# MICROCHIP PIC18F2420/2520/4420/4520

## PIC18F2420/2520/4420/4520 Rev. B3 Silicon Errata

The PIC18F2420/2520/4420/4520 Rev. B3 parts you have received conform functionally to the Device Data Sheet (DS39631C), except for the anomalies described below. Any Data Sheet Clarification issues related to the PIC18F2420/2520/4420/4520 will be reported in a separate Data Sheet errata. Please check the Microchip web site for any existing issues.

FIGURE 1: SCK PULSE VARIATION USING TIMER2/2

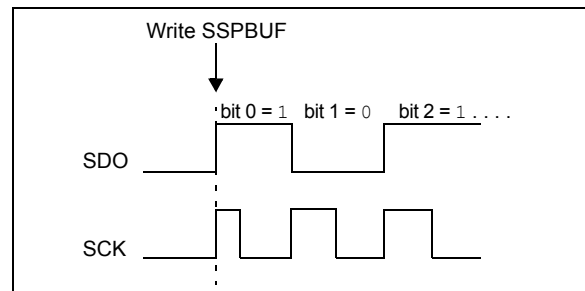
When the SPI is using Timer2/2 as the clock source, a shorter than expected SCK pulse may occur on the first bit of the transmitted/received data (Figure 1).

To avoid producing the short pulse, turn off Timer2 and clear the TMR2 register, load the SSPBUF with the data to transmit and then turn Timer2 back on. Refer to Example 1 for sample code.
